Hoonah Geothermal Corridor Quality Assurance Report of DOT Roads To Resources Project.

**Alaska Department of Transportation
Roads to Resources Project
LiDAR & Imagery
Quality Assurance Report
Hoonah Corridor**

**Written by Rick Guritz
Alaska Satellite Facility
July 28, 2015**

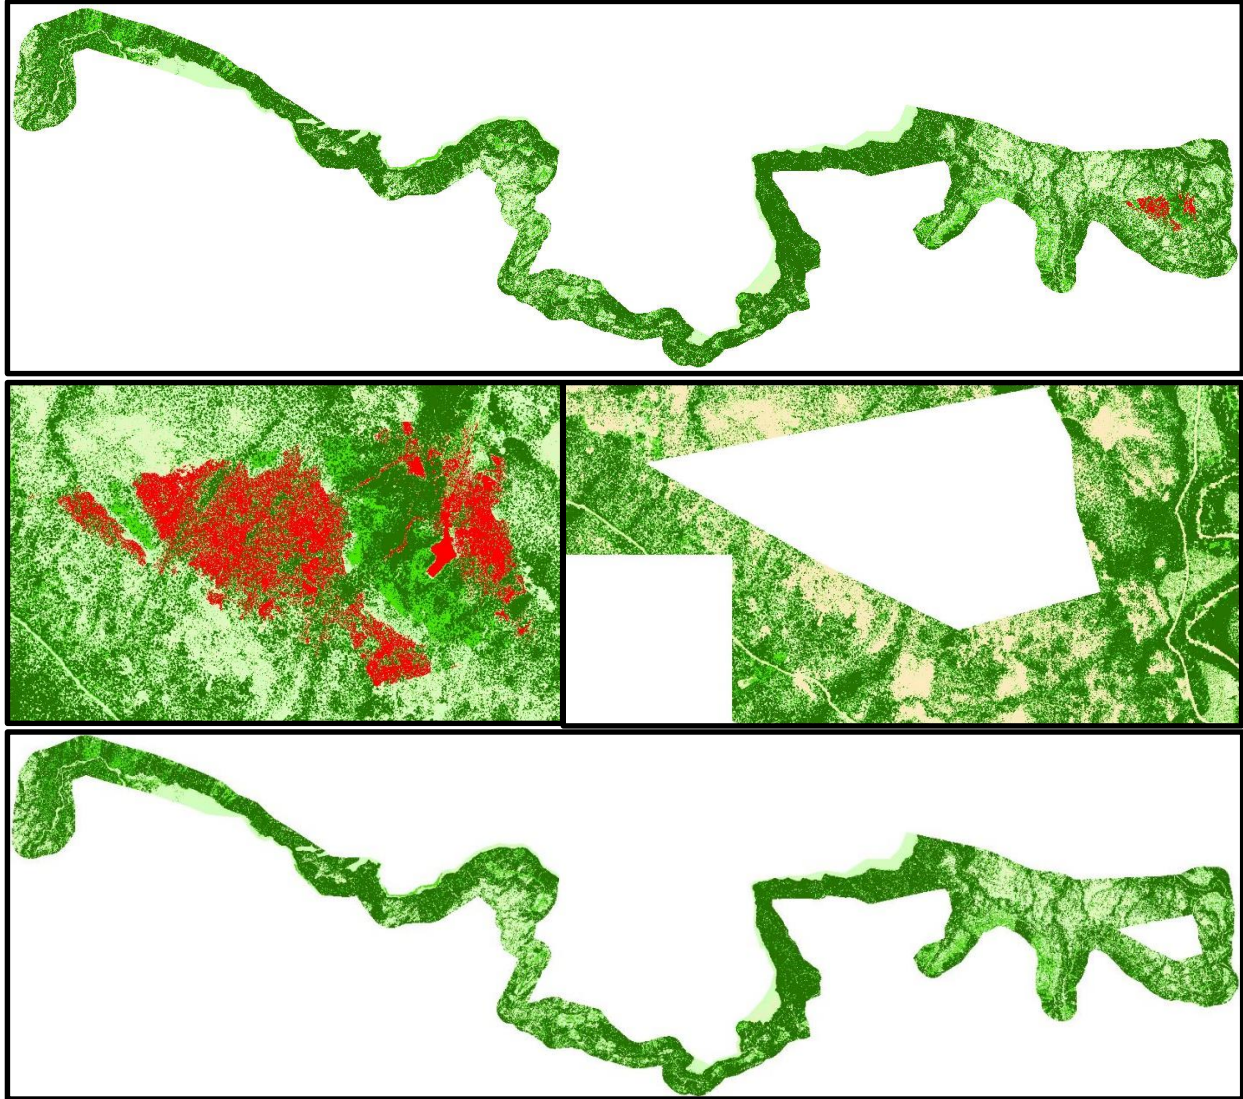
UAF completed its initial review of Hoonah Corridor – On 5/8/2015, UAF initial reports of data quality issues for Hoonah Corridor. These include: 1) the canopy height estimate which is first return DSM minus bare earth DEM should result in positive values related to above ground structure. In a small area of the Hoonah Corridor, there were larger than acceptable negative values. Areas of red indicate that the first return DSM is lower than the bare earth DEM (see Figure 31). In closer examination, values ranged from -1 to -10 feet roughly. 2) Land XML issues include: a) L22625_22525 – error loading tile saying that importing with face and neighbor info failed (see Figure 32). b) L22850_22400 – tile loads but is larger in size than other tiles (see Figure 33). No error is reported, just the visual appearance of tile is incorrect overlapping neighboring tiles. c) L22425_22550 – tile missing, not included on delivery disk (see Figure 34).

Figure 31, Canopy height classification shows height errors on west end of corridor. The height error was within the omitted hole in boundary. Tetra Tech initially decided to deliver corridor without clipping. When the height error was detected, Tetra Tech was then asked to clip to original boundary.

Delivery 2 – Tetra Tech staged fixes for Hoonah Corridor on 6/4/2015. Redelivery for Hoonah as requested. This delivery included replacement tiles for first return DSM and bare-earth DEM tiles which needed clipping. It also redelivered the requested LandXML tiles that were identified needing fixes.

UAF verified some fixes and requested further work - On 6/15/2015, UAF completed quality Assurance review of delivery 2. The clipped first return DSM tiles and LandXML tile L22425_22550 were verified. The clipped bare earth DEM tiles has bad histograms with very large value ranges. Two of the requested LandXML tiles were still not fixed. UAF requested these to be fixed and redelivered.
